City Planning Department

Memo

To: Cranston City Plan Commission
From: Joshua Berry, AICP - Senior Planner / Administrative Officer
Date: May 28, 2021
Re: "145 Wayland Avenue" Preliminary Plan - Minor Subdivision with street extension

Owner: Bryan White
Applicant: Gary White
Location: 145 Wayland Avenue & 0 Elmhurst Avenue, AP 12/5, Lots 294-299
Zone: A-6 (Single-family dwellings on lots of minimum areas of 6,000 ft²)
FLU: Single Family Residential 7.26 to 3.63 units per acre

SUBDIVISION PLAN

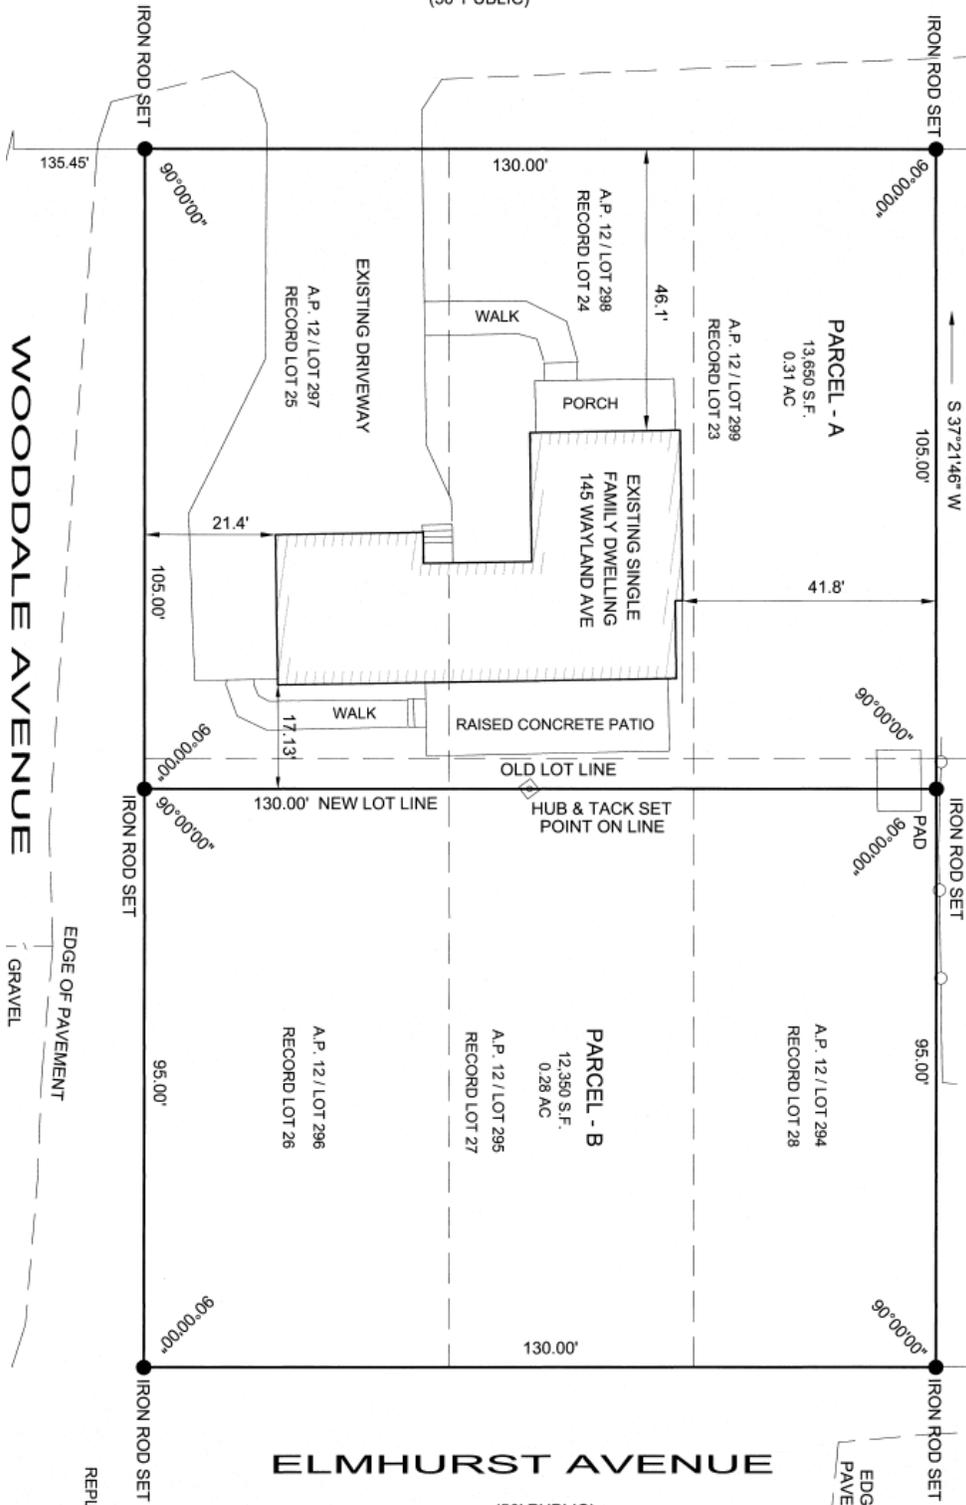
Staff noticed that the tree clearing line is very close to the proposed retaining wall and that there are two proposed grade lines in the city's right-of-way. Staff spoke to the applicant's engineer about the concern that this could cause tree disturbance beyond what is shown on the plans. The engineer, Bill Lavery, PE acknowledged staff's concern and explained how the retaining wall and grading could be accomplished with minimal disturbance to the existing vegetation in the unimproved right-of-way. Staff was satisfied by the explanation but proposes a condition to help ensure the protection of the existing buffer to the Job Lot by requiring the minimal practical disturbance of the trees.

1. The applicant shall obtain relief from the Zoning Board of Review, as applicable, and shall include the decision letter as part of the Final Plan application.
2. The applicant shall obtain approval from Veolia Water for the sewer design and include the approval letter as part of the Final Plan application.
3. The applicant shall pay the Eastern Cranston Capital Facilities Impact Fee in the amount of \$1,186.92 (\$593.46 per new unit) at the time of Final Plan recording.
4. The applicant shall limit tree disturbance within the City’s public right-of-way to the greatest practical extent.
